30RA-RH 05-33 / 30RB-RQ 17-33 WATER PUMPS STATUS

This bulletin presents a clear status on water pump modifications and replacements for 30RA-RH / 30RB- RQ following ERP regulations (N°640/2009) and product design evolution.

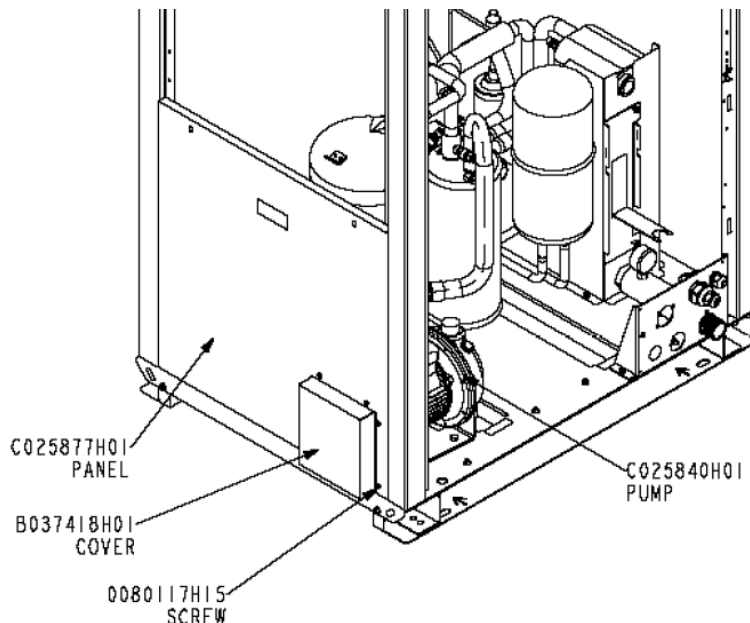
UNIT	PRODUCTION DATE UP TO END MARCH 2004		PRODUCTION DATE STARTING BEGINNING APRIL 2004 ("B SERIES")	
	Factory mounted	For replacement	Factory mounted	For replacement
30RH017	B033309H01 (Old design)	B033309H01 (New design) + 96960786 (Adaptor) + 241G4033 (Coupling)	C024525H01	Same part number
30RH021			C024525H01	
30RH026	B033310H01 (Old design)	B033310H01 (New design) + 96960787 (Adaptor) + 241G4033 (Coupling)	C024526H01	C025840H01* + B037418H01 (cover)
30RH033			C024526H01

* Pump longer than the original one. A hole must be perforated on the rear panel.
